PROJECT: JEDDAH OPERA HOUSE

TITLE: OPERA BUILDING
VERTICAL TRANSPORTATION
PART 001
PLANS - LIFT SHAFT (L06)

DRAWING No: JOH-OTS-S5-01-056-001-ZZ-SD-VT-011020 REV: S01

SCEC – K&A Reviewed
KHATIB & ALAMI
SAUDI CONSOLIDATED ENGINEERING COMPANY
Code B – Approved with Comments (Do not Resubmit)

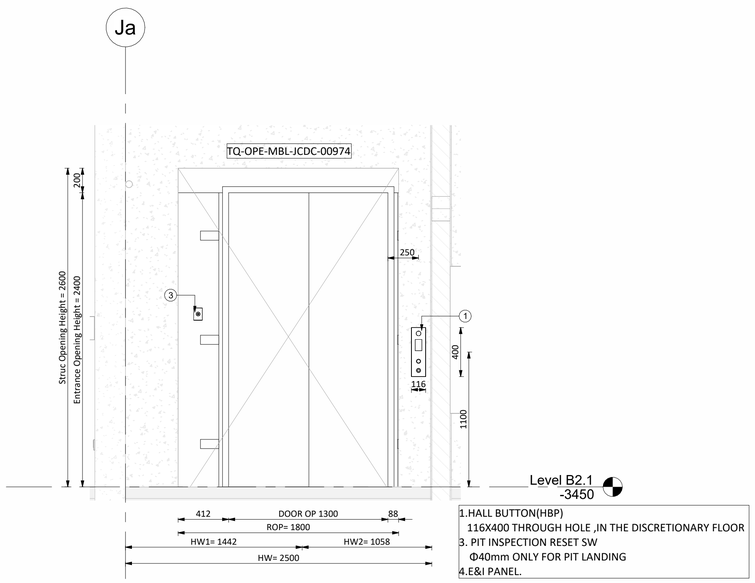
the Note provided on the drawing is rejected and the word (by client)shall be replaces to (by main contractor):

1 Door Elevation At "B2" Floor (FRONT) - ELEV-L6
1 : 25

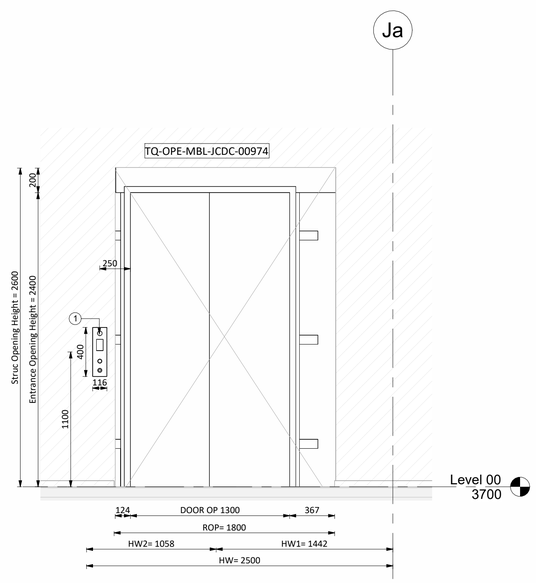
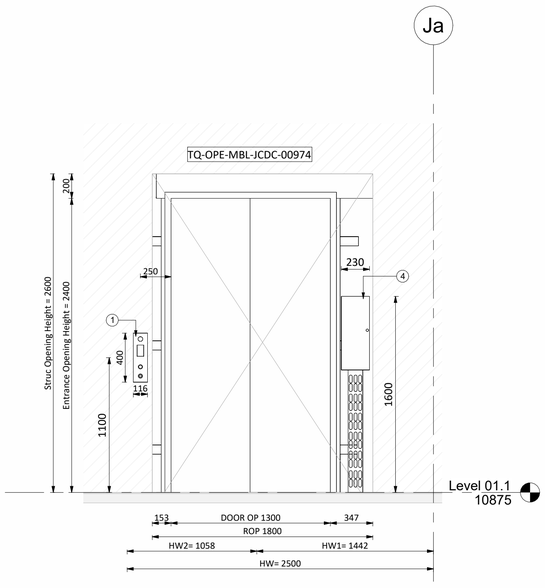
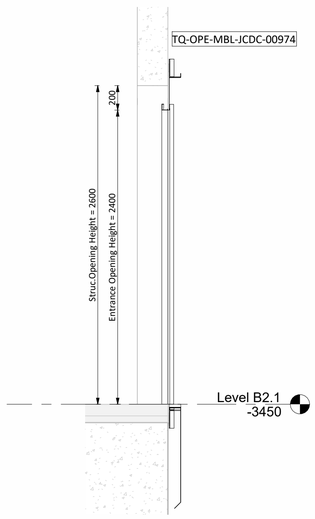
call button centerline height of 1100 mm is ok subject that the installation remains fully compliant with EN 81-70 and the applicable accessibility requirements
